Re: Percolation Test Plat Review

Review of the Percolation Test Plat submitted April 14, 2006 by KCE requires the following revisions for further review and approval:

RE: **Percolation Test Results**
Application: A523273 & A523837
Property ID: 13515 Highland Road
Tax Map: 34, Parcel: 181
&
13500 Brighton Dam Road
Tax Map: 34, Parcel: 430

PERCOLATION TEST LOCATION PLAN
LOTS 9 & 10
PARCELS 181, 430, TAX MAP 34, GRID 8
WOOD RIDGE, HOWARD COUNTY, MARYLAND

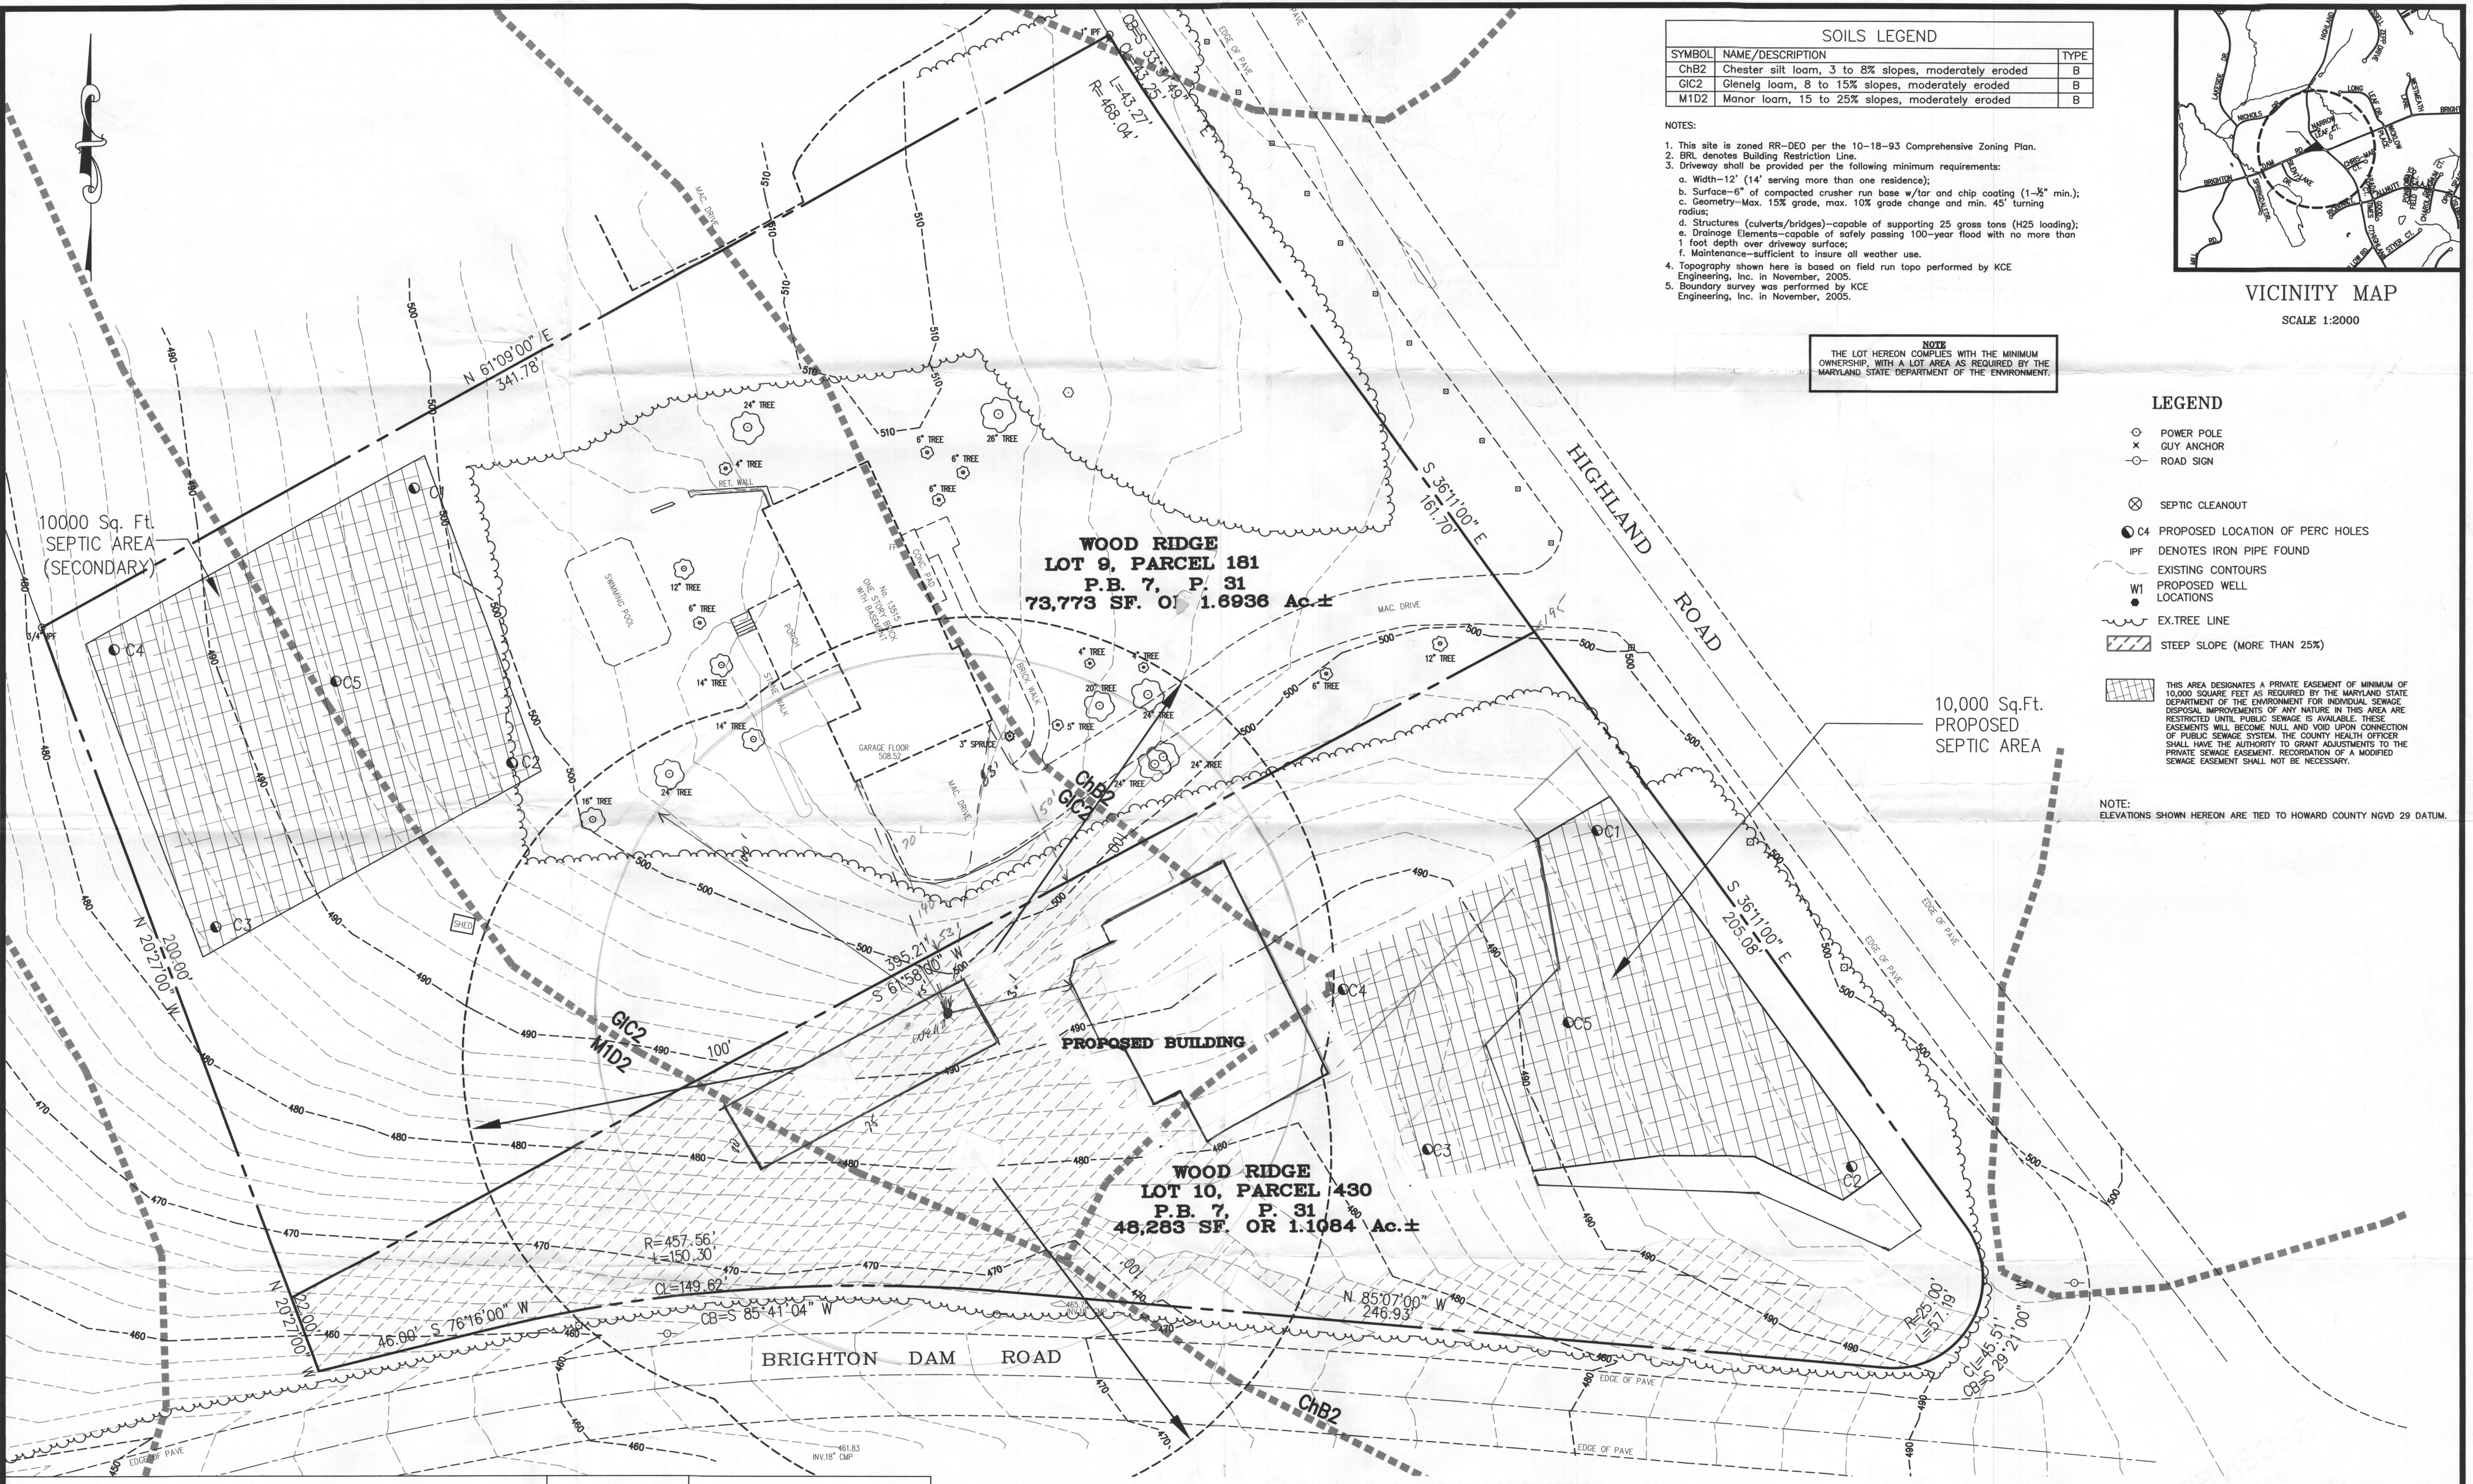
A **licensed surveyor** MUST submit a Percolation Certification Plan showing the following information and changes to the percolation test plan:

- actual locations and elevations of all excavated test holes with hole numbers matching sanitarian notes
- identify percolation test holes as passed or failed

- overlay the plan with soil map
- calculate septic reserve area's total square footage after adjustment to SDA
- topography with 2' contours,
- propose house sites with a driveway location (s)

- propose three acceptable well locations from septic disposal area
- identify slopes if greater than 24.99% and ensure septic area 25' away from them
- show the predominate swale for parcel 430

- field locate actual location of all existing wells and septic systems within 100 feet of all property boundaries
- include in General Notes the zoning of the property and note that lot lines will remain as documented on the final record plat dated June, 1959.

- Add in the General Notes the drilled proposed well site will have grout surpassing the minimum state requirement per the Approving Authority's discretion

PERCOLATION TEST LOCATION PLAN
LOTS 9 & 10
PARCELS 181, 430, TAX MAP 34, GRID 8
WOOD RIDGE, HOWARD COUNTY, MARYLAND

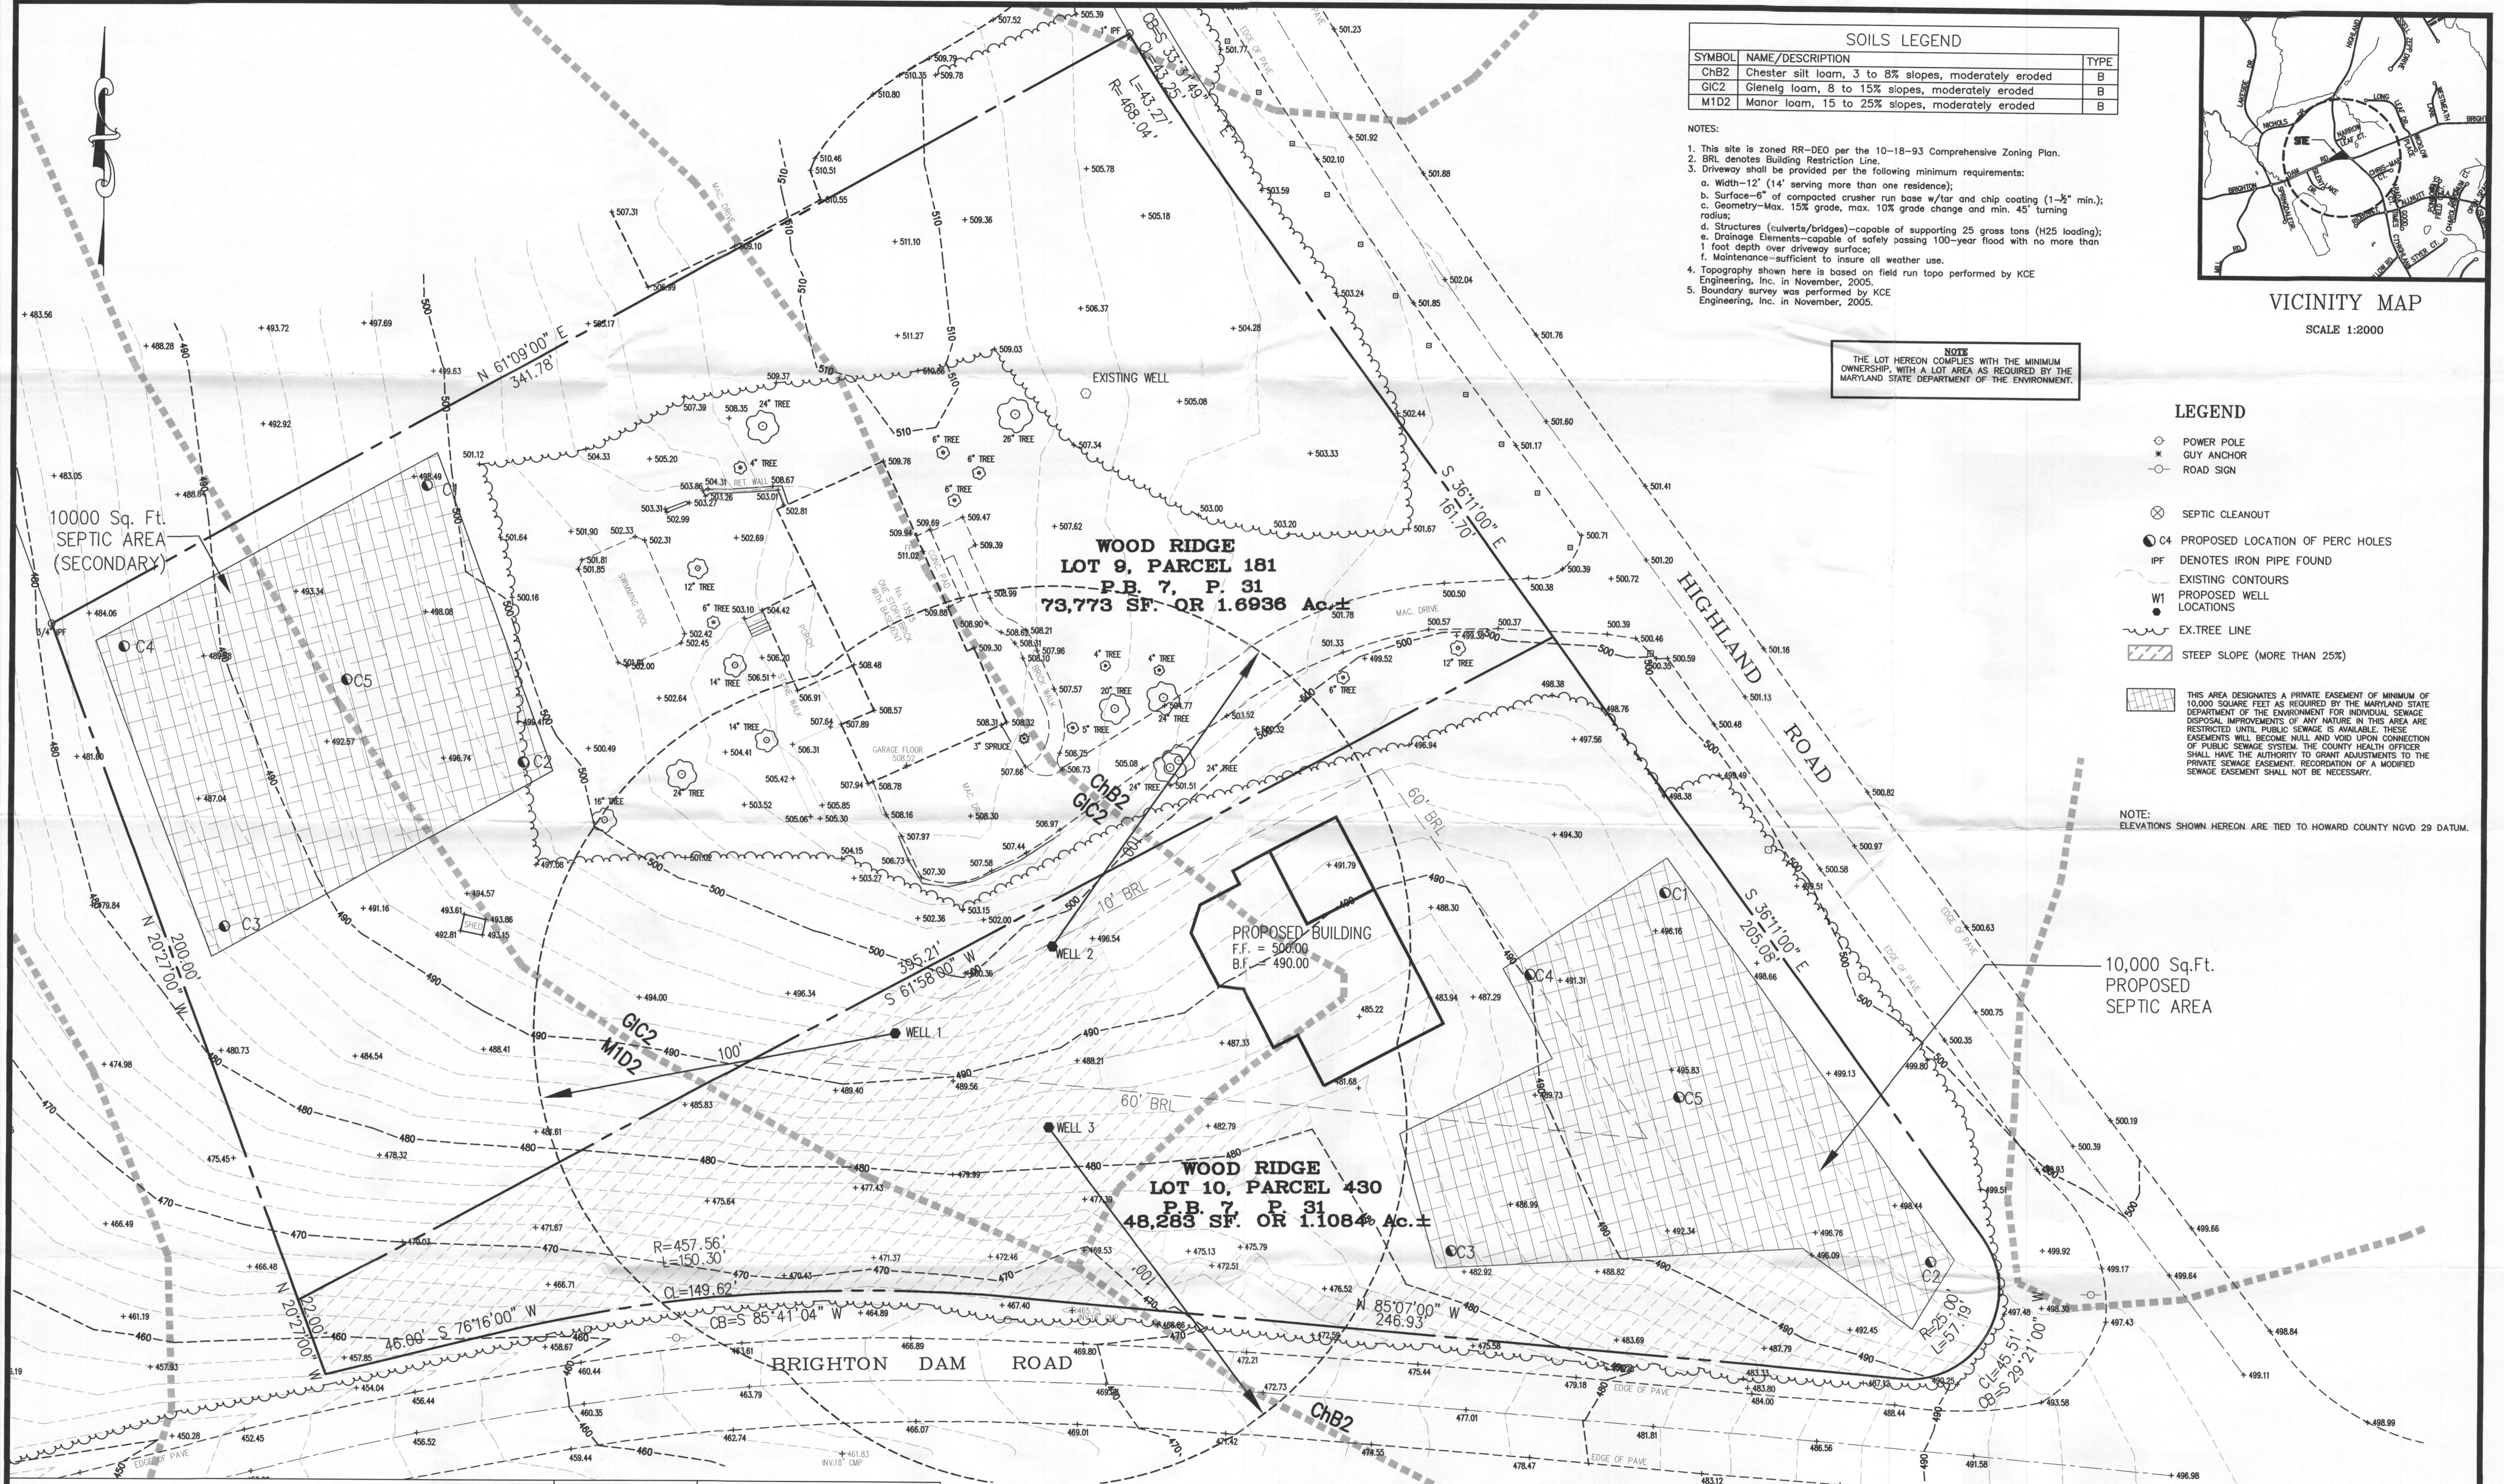
For your existing lot of record

- Show the 100' well radius for your existing well
- Show the location of the existing septic tank and vicinity of dry well
- Label the pool as an above ground pool
- Connect the perimeter of the septic area as a line directly from C2 to C1 passing holes
- Show the layout of two systems at the highest elevation of the proposed future repair area and delete any septic area that is not needed and not supported with percolation test holes (southern side of septic area)
- Add a statement on the lot line separating the proposed buildable lot and your southern lot line for clarity: "Existing lot line since 1959, no adjustments proposed". Still maintain note #6 in General Notes

For your adjacent lot of record

- Keep all percolation test holes as shown
- Maintain 25' setback from any 25% slopes and 25' off the centerline of the swale
- Although percolation test hole A2 passed, there is not enough area for a 40' length trench on contour; shorten the septic disposal area perimeter line uphill until a 40' length trench is supported in the area while maintaining the above mentioned setbacks.
- Adjust the septic tank sanitary line from the house to enter the tank from the end of the tank, not the corner of the tank or its side.
- Propose the pump tank location near the elevation of the septic tank to allow gravity fall into the pump chamber.

As a reminder, the septic trench design *for your address* are as follows: Inlet of pipe at 2', bottom of trench at 4', trench width 3' wide, trenches 9' edge to edge . Percolation test rate supports 180 cubic feet of adsorption area per bedroom. Design *for the proposed buildable* lot is as follows: At the highest elevation of the septic area, invert at 4', bottom of trench at 9', trench width 2' wide. Place trenches 7' edge to edge. Included is a copy of the trench design spec sheet.
